Addendum No. 4
February 24, 2020

Project: Knutson Theatre Renovations
University of South Dakota
Vermillion, South Dakota
OSE Project #R0619--19X
Architecture Incorporated Project #2856

Scope of this Addendum:

4.11

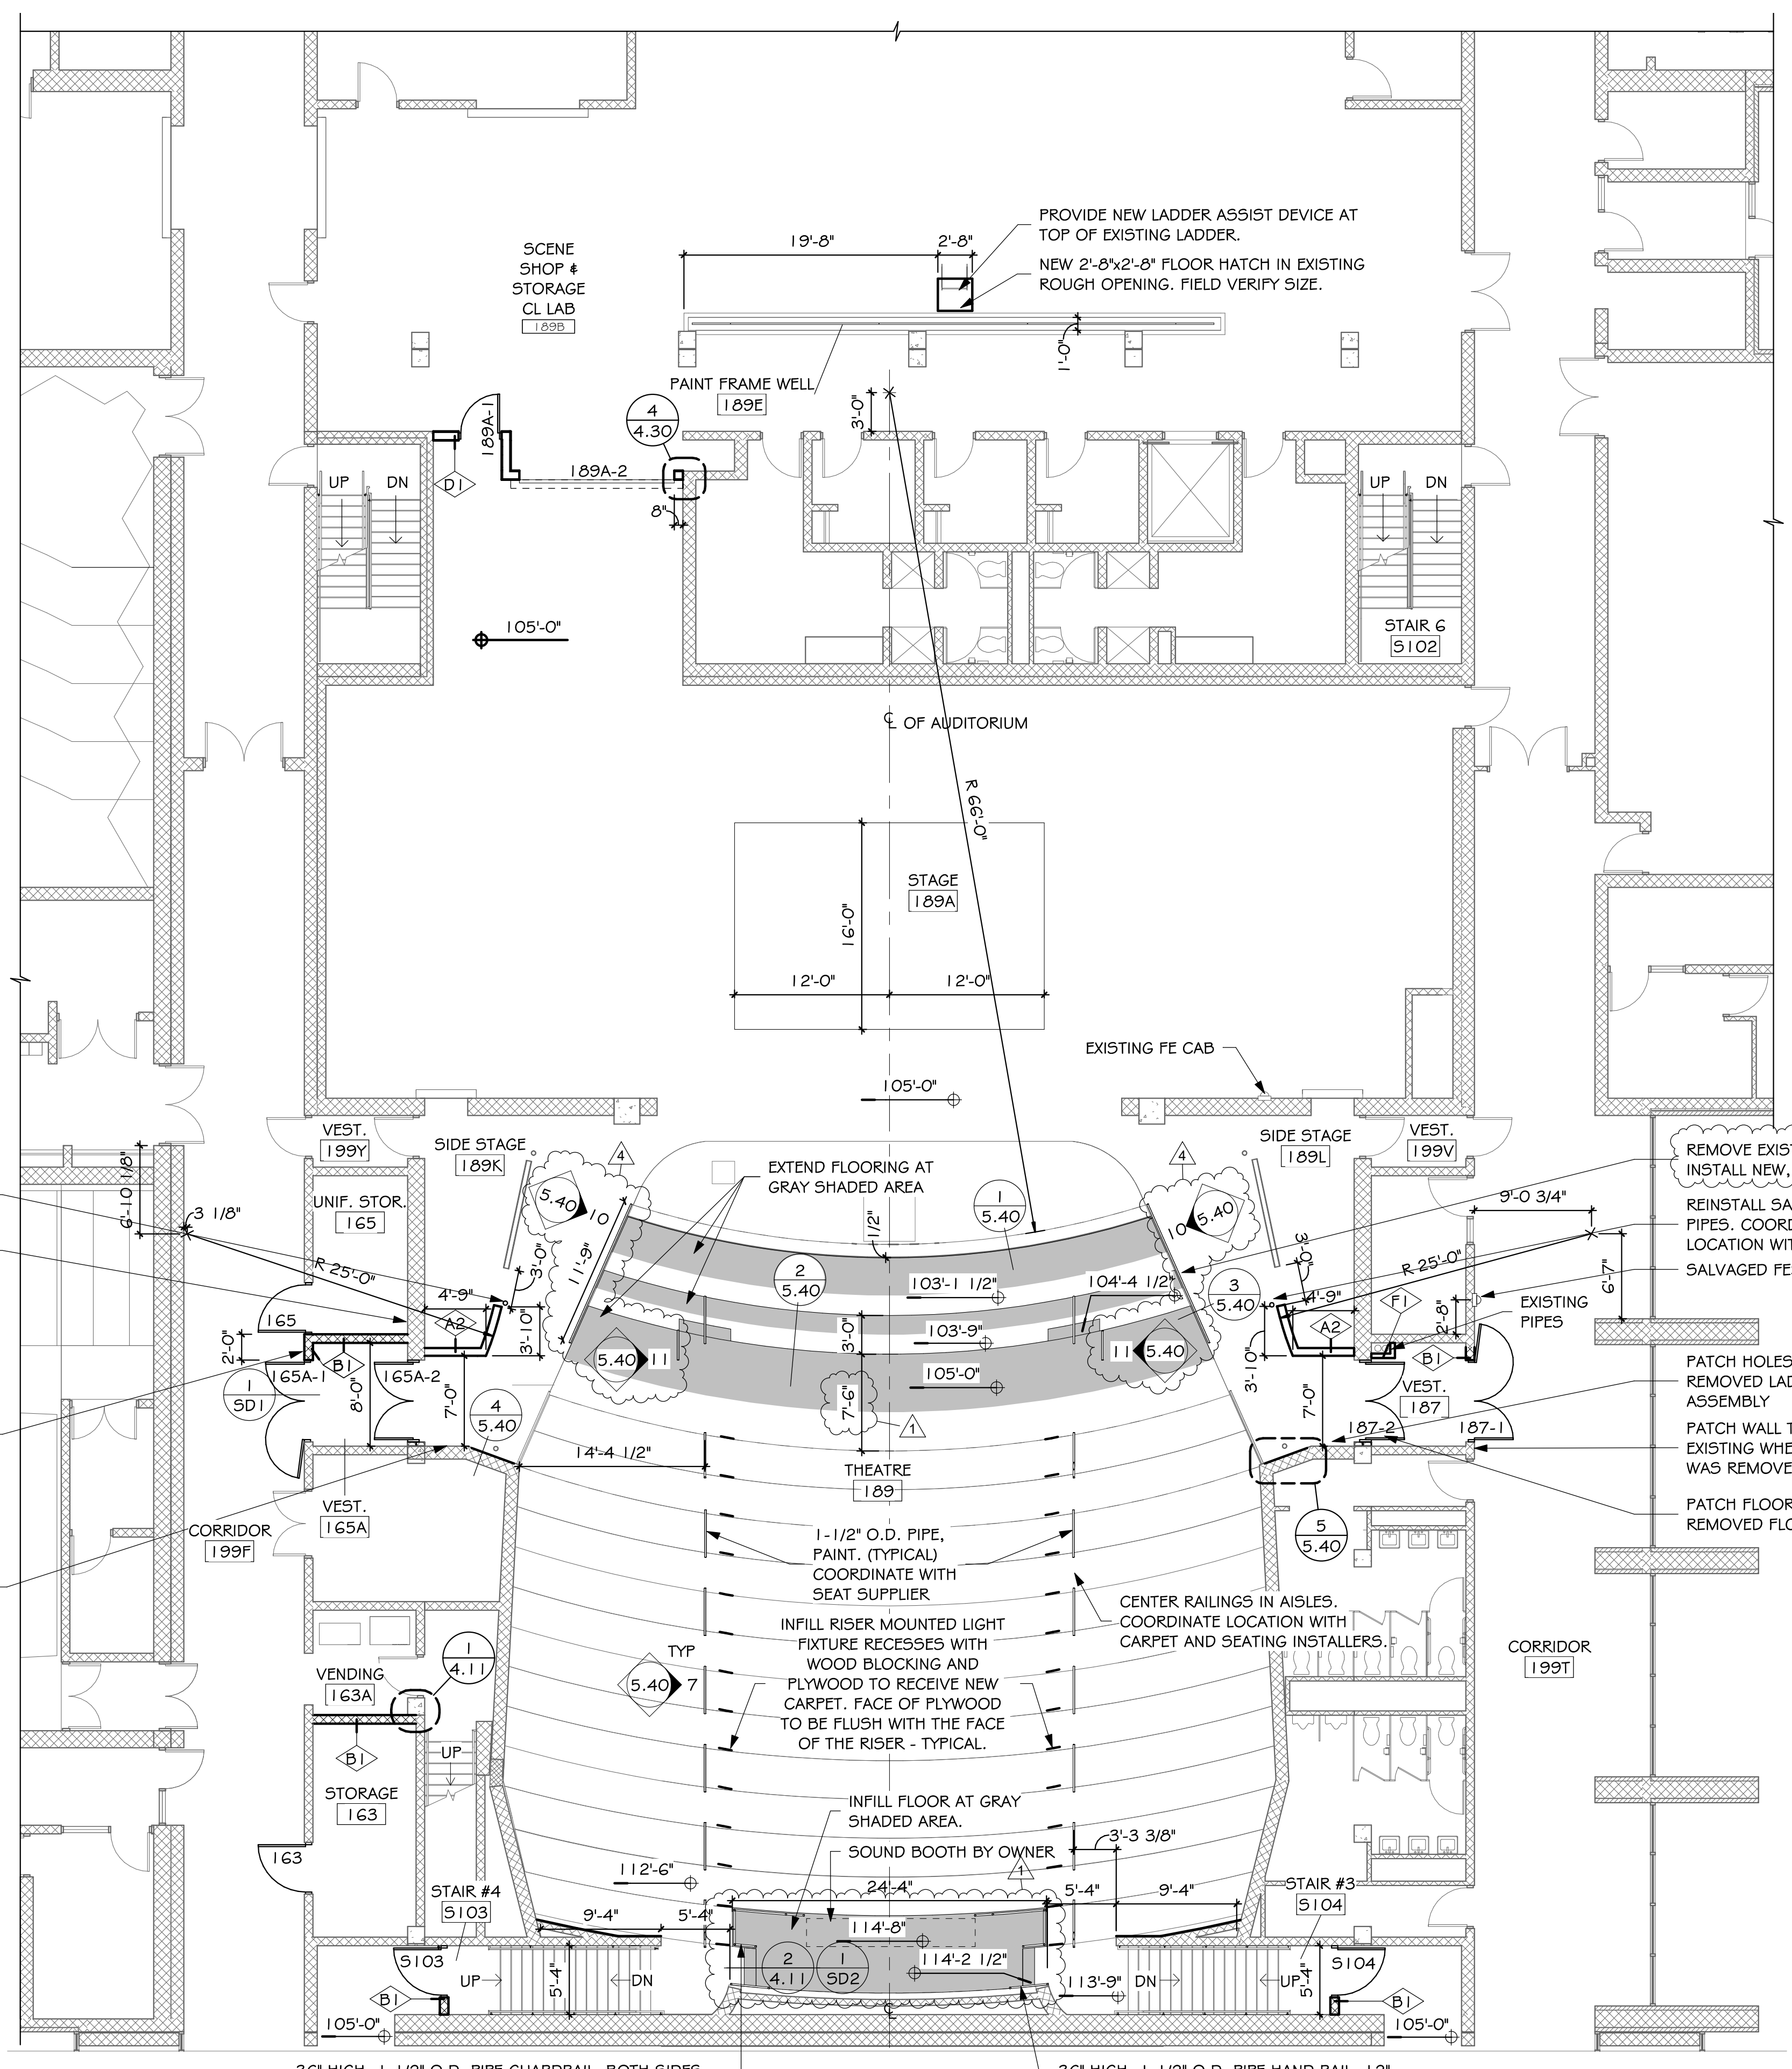
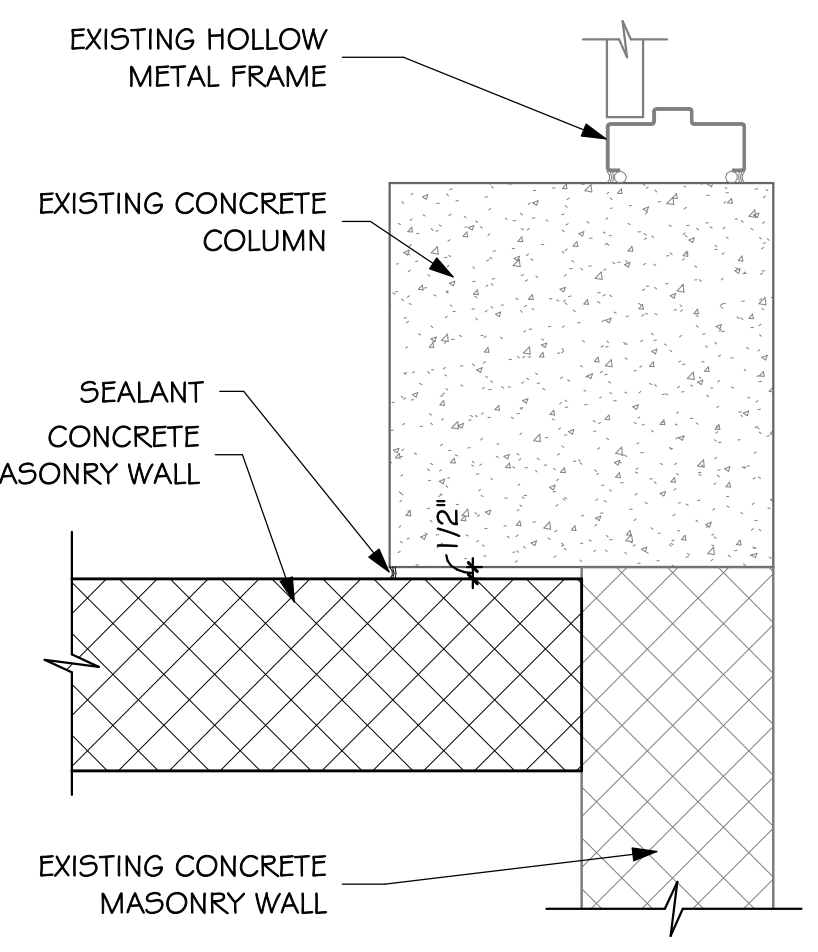
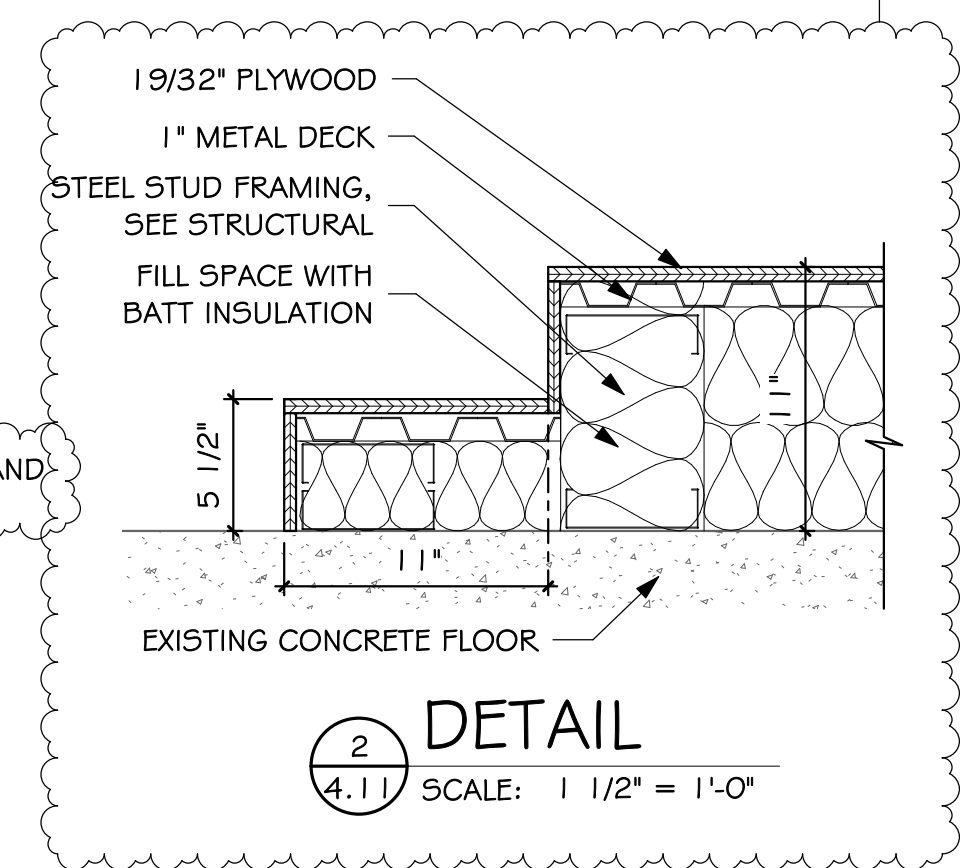
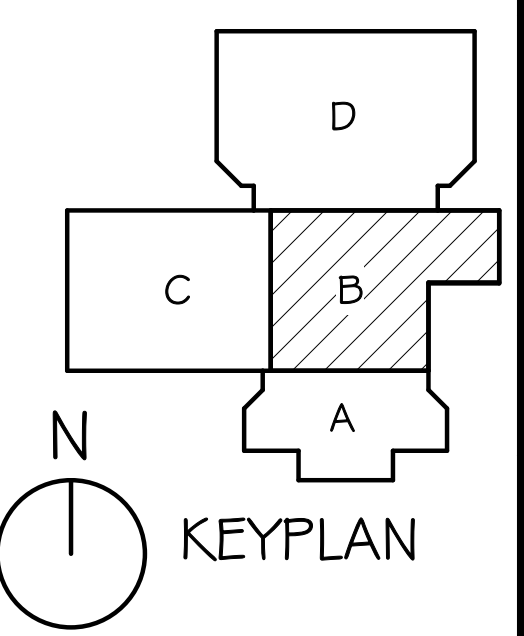
- a) Clarification at Side Stages 189K and 189L – the two salvaged light pipes indicated to be reinstalled adjacent the north end of the new walls shall be mounted to the new walls. These light pipes shall be mounted on the Theatre 189 side of the walls 12" south of the north end of the wall. The bottom of the vertical pipe shall be 7'-0" above the finished floor; the top shall extend to the top of the new walls. The vertical pipe shall be mounted such that it is 8" off the face of the wall and braced back to the wall with four 1 - 1/2" diameter schedule 40 pipe braces equally spaced. Provide blocking in the new walls accordingly. Note the remaining four light pipes shall be reinstalled using the existing floor, overhead, and horizontal connection hardware at their current locations.

- b) Refer to revised Drawing Sheet 4.11 (dated February 24, 2020) attached to the end of this addendum for modification of railing extents and added railing elevation keys within Theatre 189. Note the rail in front of seating Row 'D' has been omitted.

10 SOUND BOOTH RAIL ELEVATION
5.40 SCALE: 1/2" = 1'-0" OPPOSITE SIDE OF SOUND MIX BOOTH IS SIMILAR

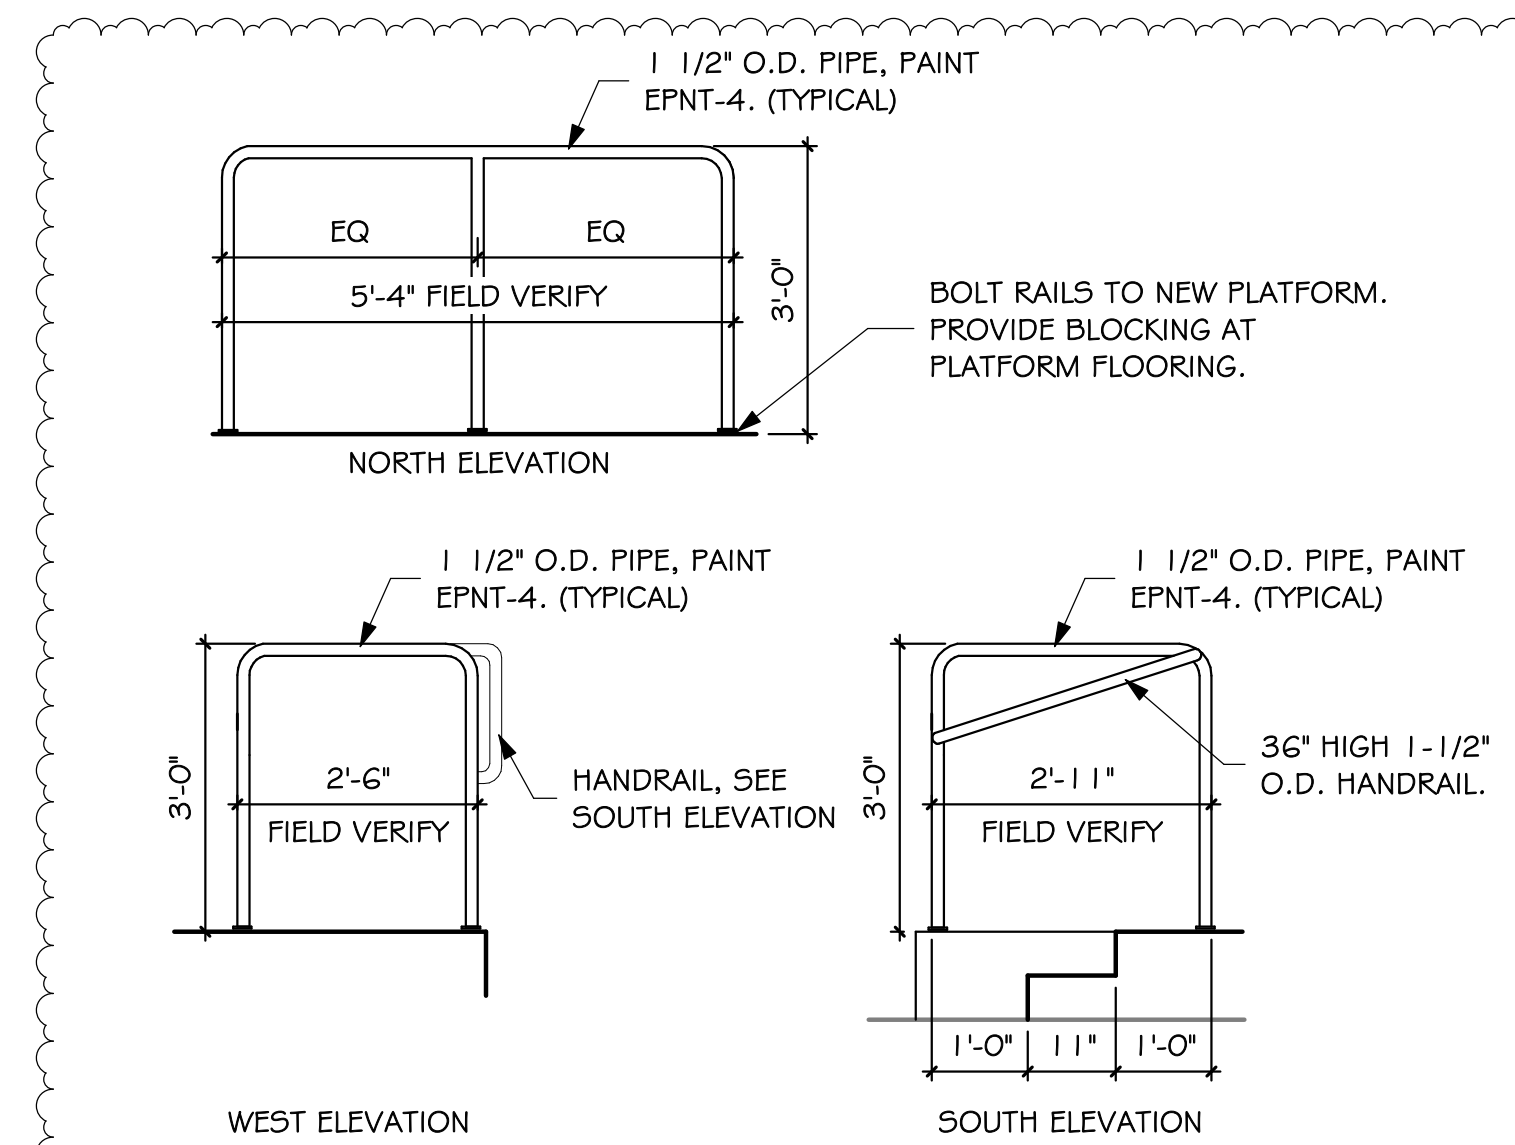
- a) Refer to revised Drawing Sheet 5.40 (dated February 24, 2020) attached to the end of this addendum for modified and added details of railings within Theatre 189. Note rails elevated at 10/5.40 occur at the east and west sides of the sound mix booth at the south side of Theatre 189. Rails shall be painted EPNT-4.
